Subject: Comments regarding NUREG-1437, Supplement 14
R. E. Ginna Nuclear Power Plant
Docket No. 50-244

Rochester Gas and Electric is providing comments regarding NUREG-1437, Supplement 14, issued June 2003. Please consider these comments when developing the Final Supplemental Environmental Impact Statement for the Ginna Station License Renewal Application.

ATTACHMENT A: RG&E COMMENTS ON NUREG-1437, SUPPLEMENT 14

ATTACHMENT B

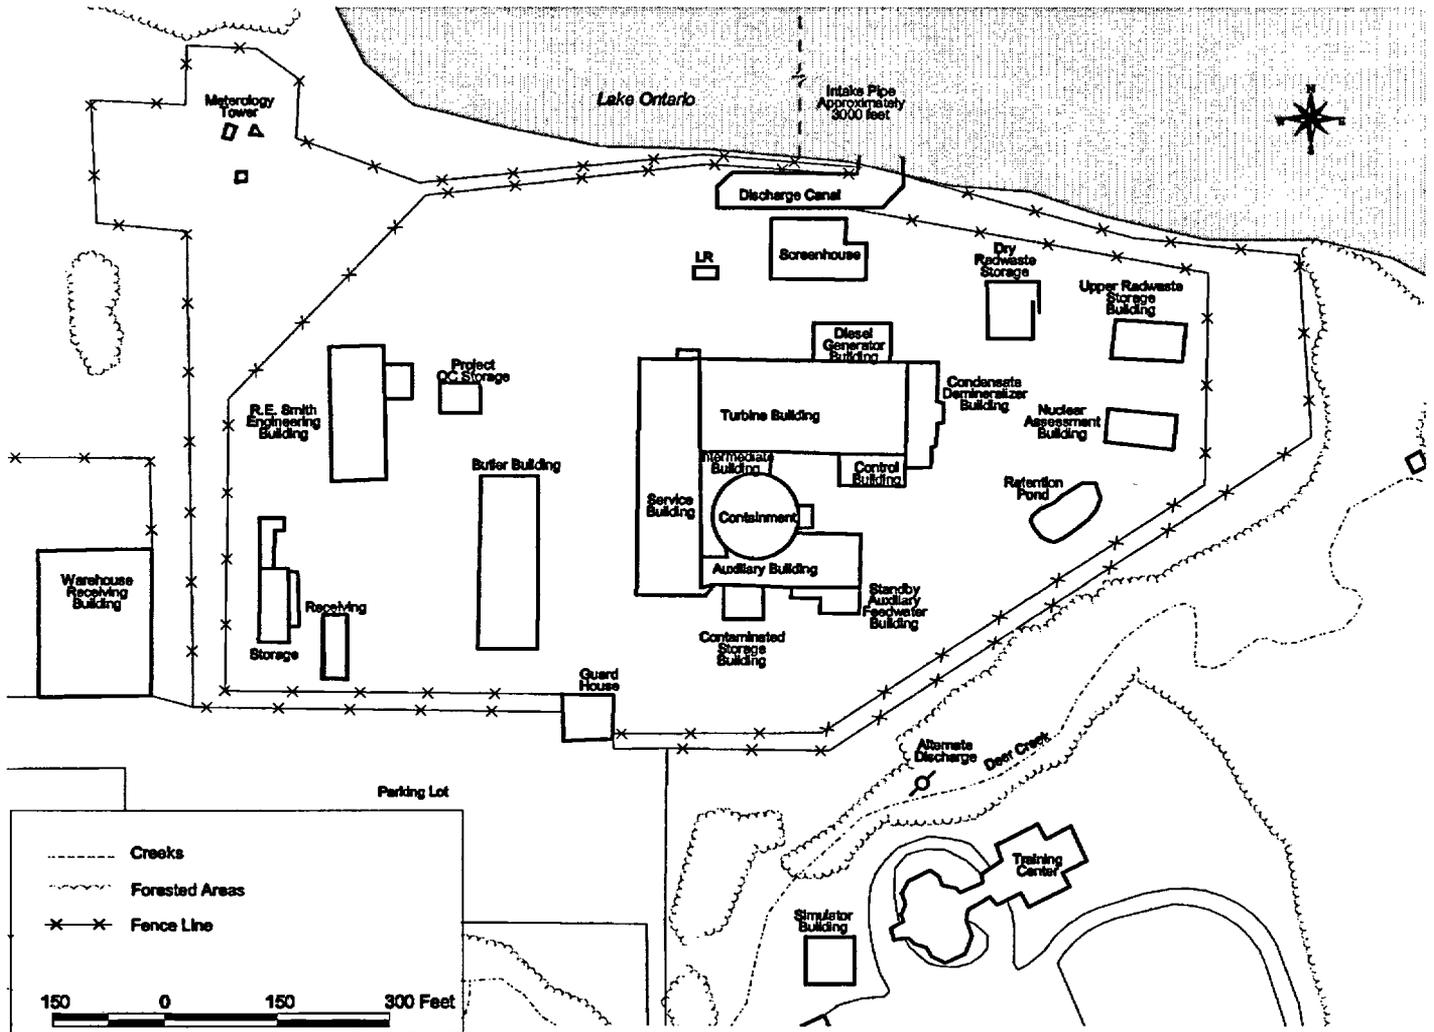
- Comment 1:** There is a typographical error on page 2-1, line 29. 0.9 km should be 2.4 km.
- Comment 2:** Minor changes should be made to Figure 2-3, as provided in Attachment B.

ATTACHMENT C

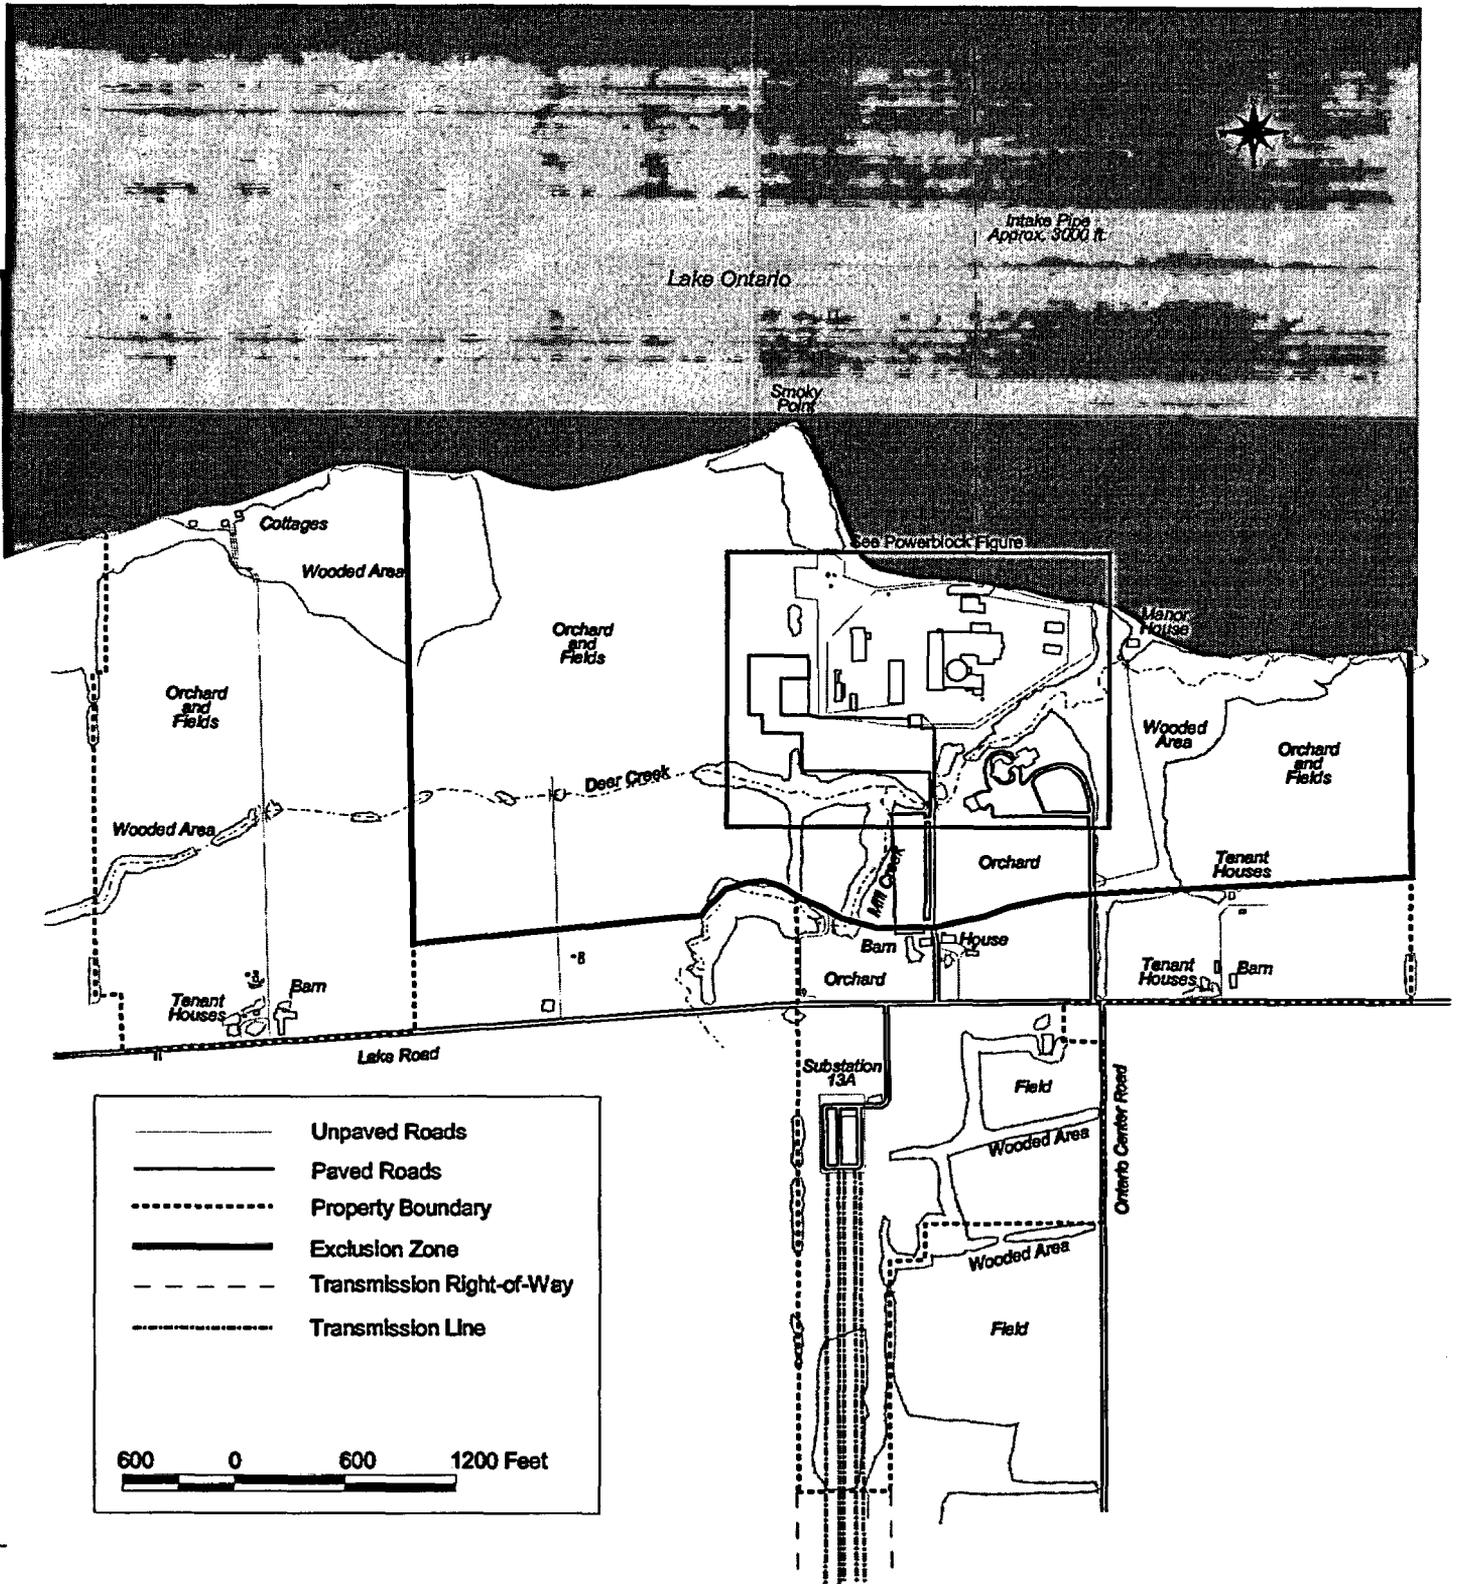
- Comment 3:** Minor changes should be made to Figure 2-4, as provided in Attachment C.
- Comment 4:** In Section 2.2, page 2-17, line 25-27, reference is made to a land transaction. This has not occurred; therefore, this sentence should be deleted.
